# RENESAS TECHNICAL UPDATE

Product Category	MPU/MCU		Document No.	TN-RX*-A0237B/E	Rev.	2.00
Title	RX230 Group, RX231 Group, RX23W Group Errata to User's Manual: Hardware Regarding the Realtime Clock (RTC)		Information Category	Technical Notification		
Applicable Product	RX230 Group, RX231 Group, RX23W Group	Lot No.	Reference Document	RX230 Group, RX231 Group User's Manual: Hardware Rev.1.20 (R01UH0496EJ0120) RX23W Group User's Manual: Hardware Rev.1.00 (R01UH0823EJ0100)		
		All

This document describes corrections to the "Realtime Clock (RTC)" chapter in User's Manual: Hardware for the applicable products.

Figure 28.3 Clock and Count Mode Setting Procedure

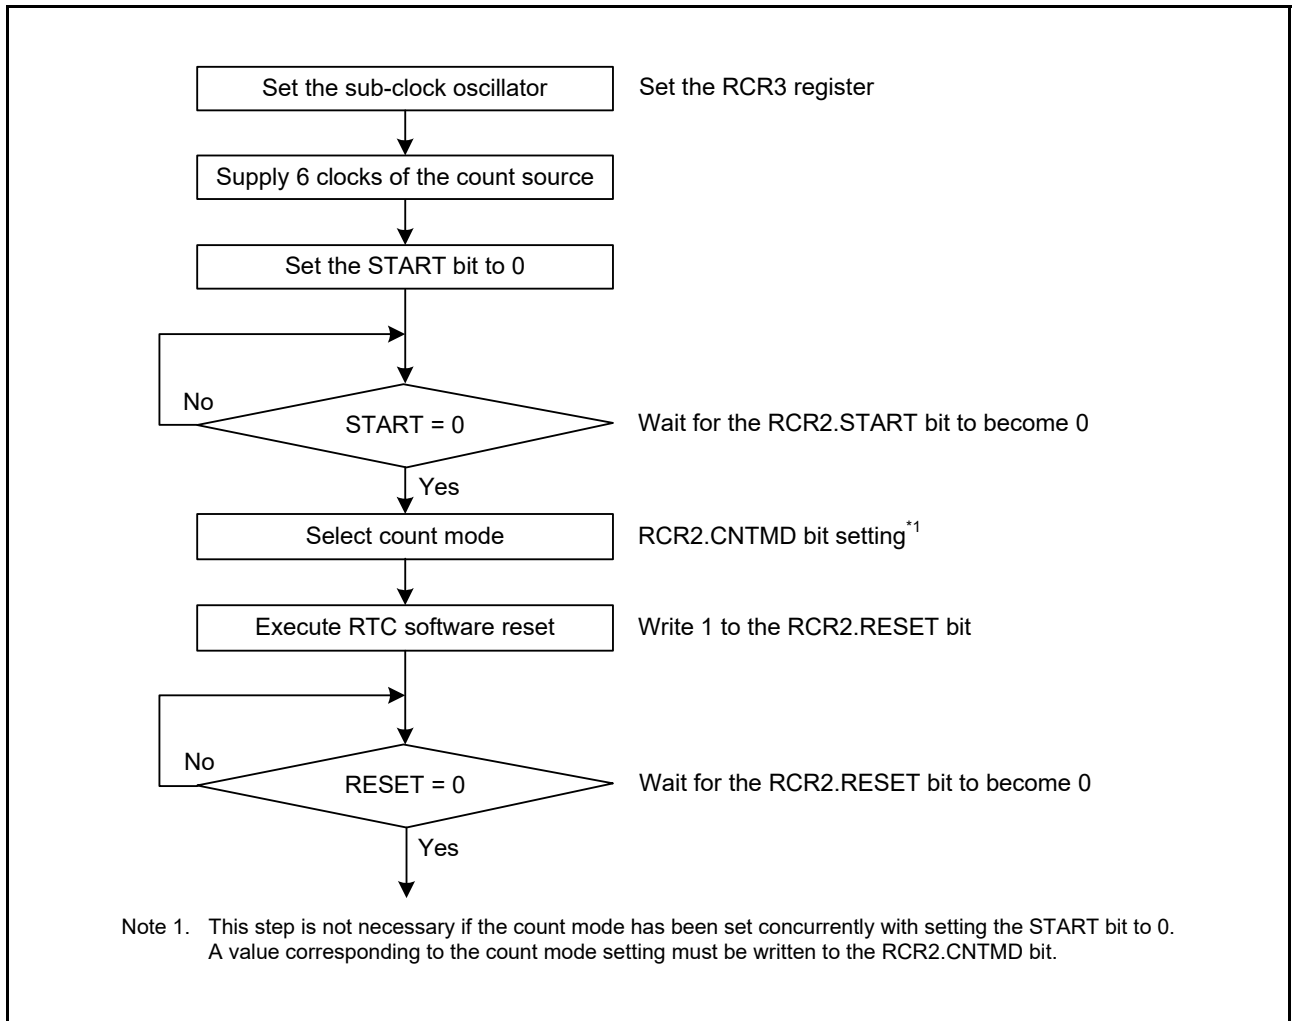
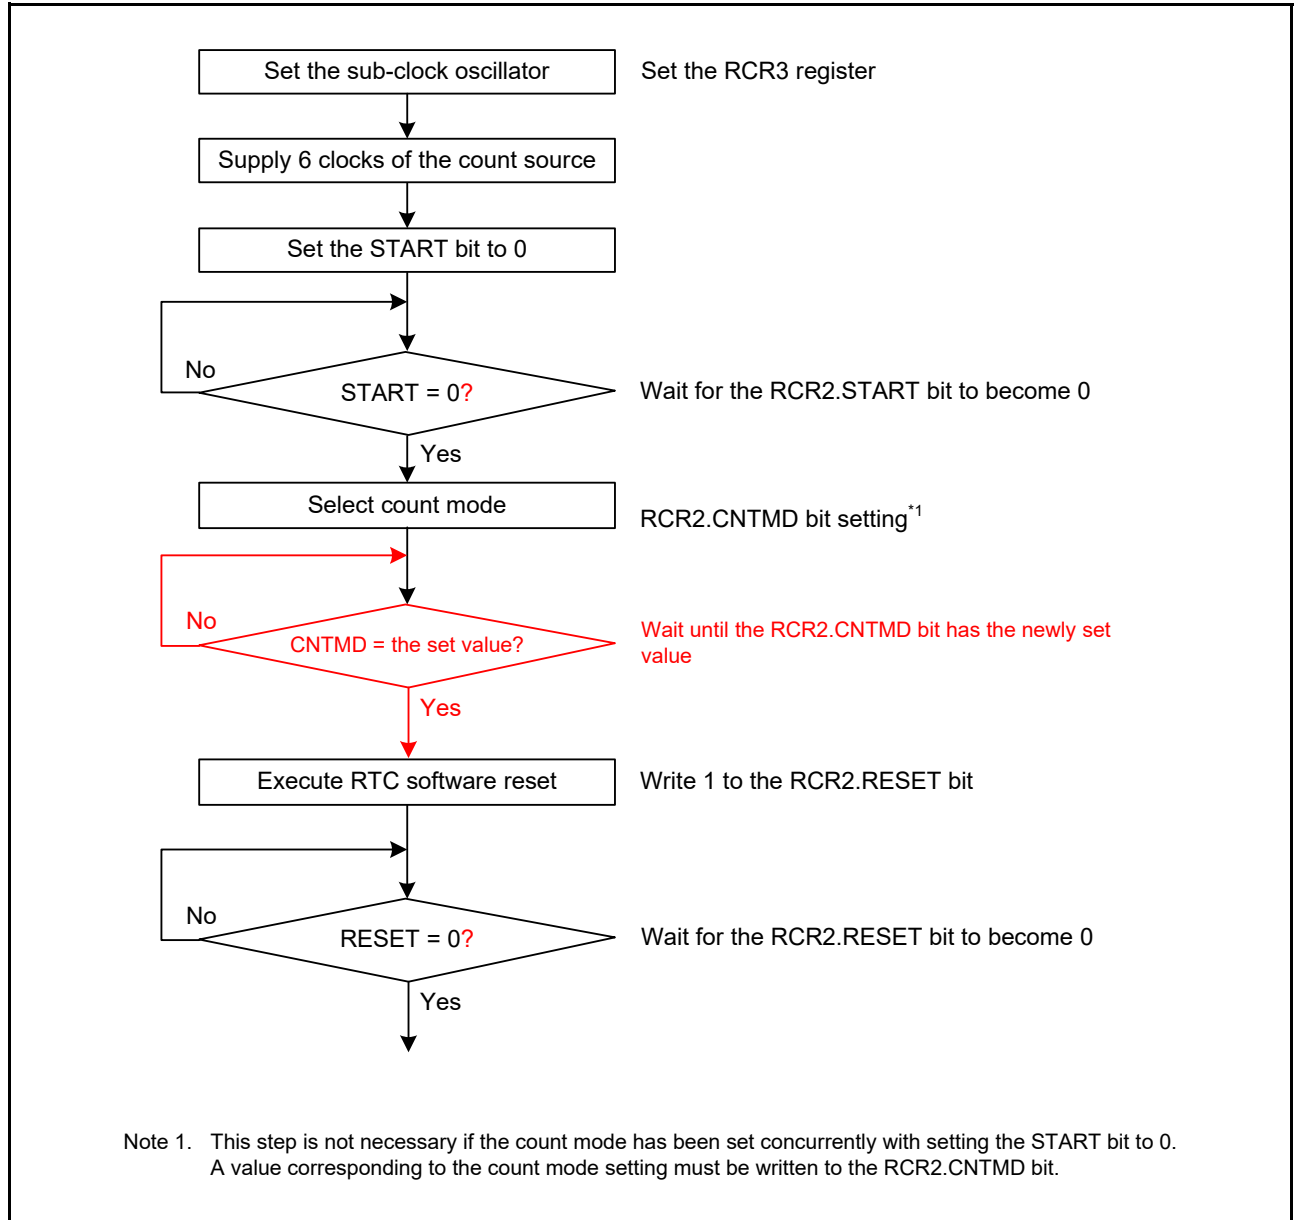
The setting procedure described in Figure 28.3, Clock and Count Mode Setting Procedure is corrected as follows.

Figure 28.14 Initialization Procedure

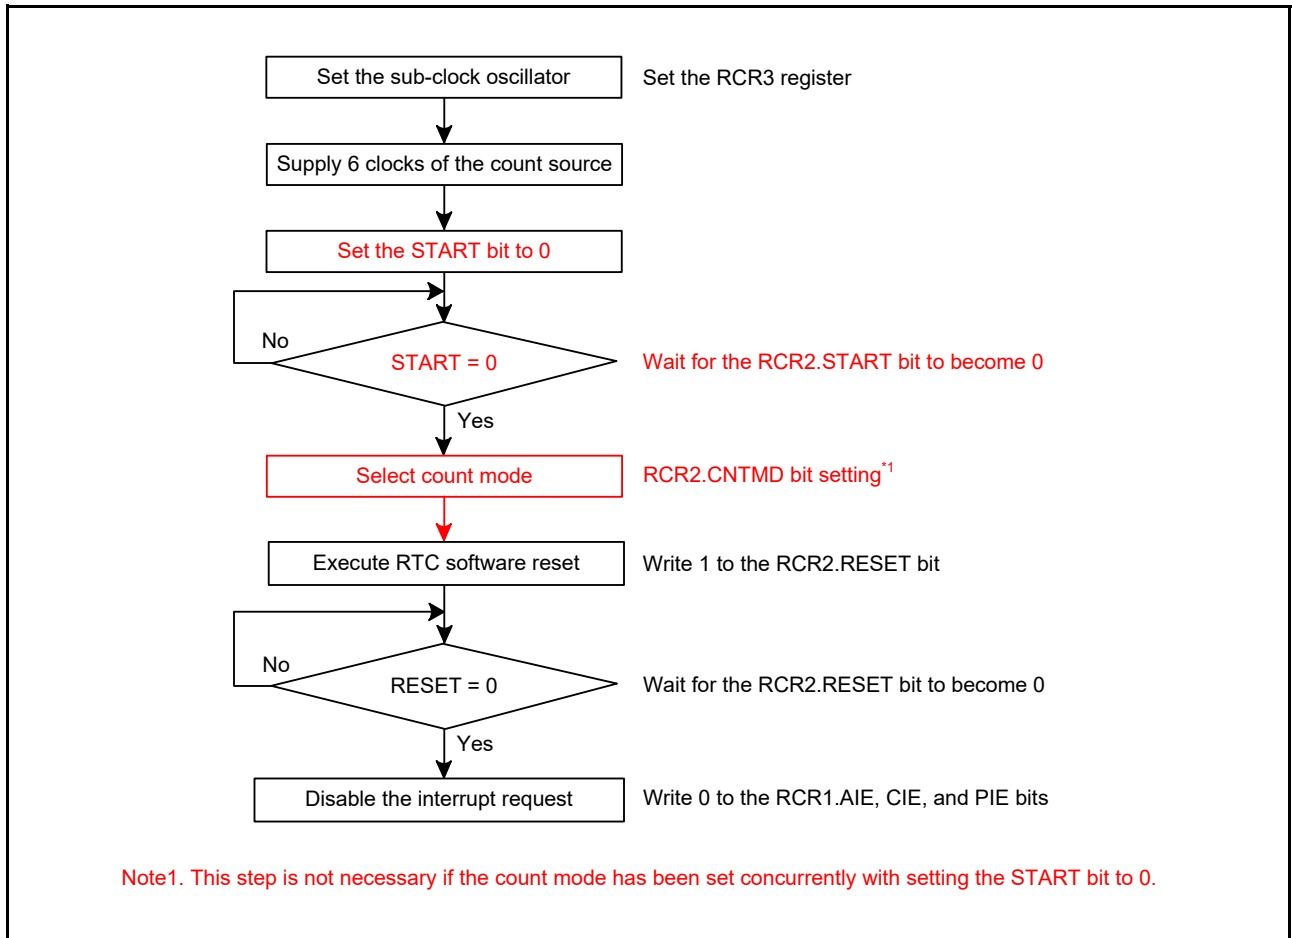
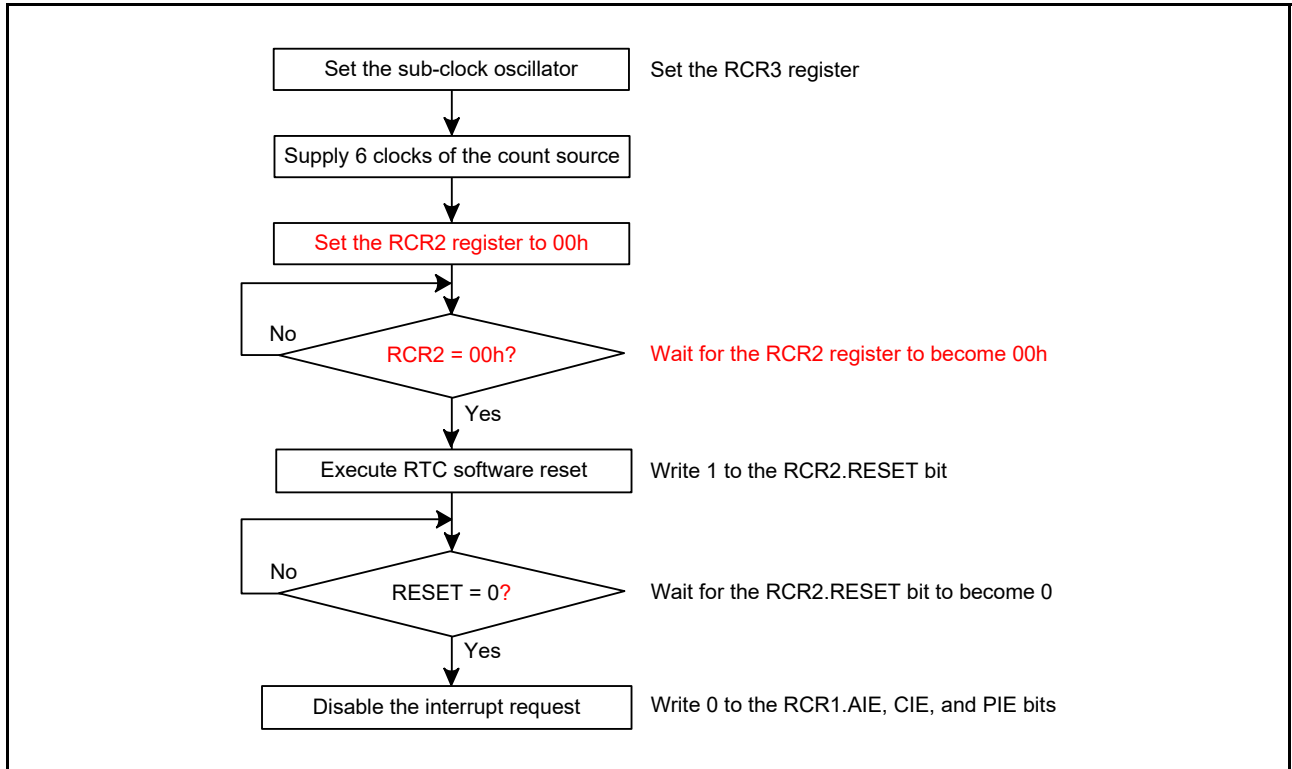
The initialization procedure described in Figure 28.14 of section 28.6.7 Initialization Procedure When the Realtime Clock is Not to be Used is corrected as follows.
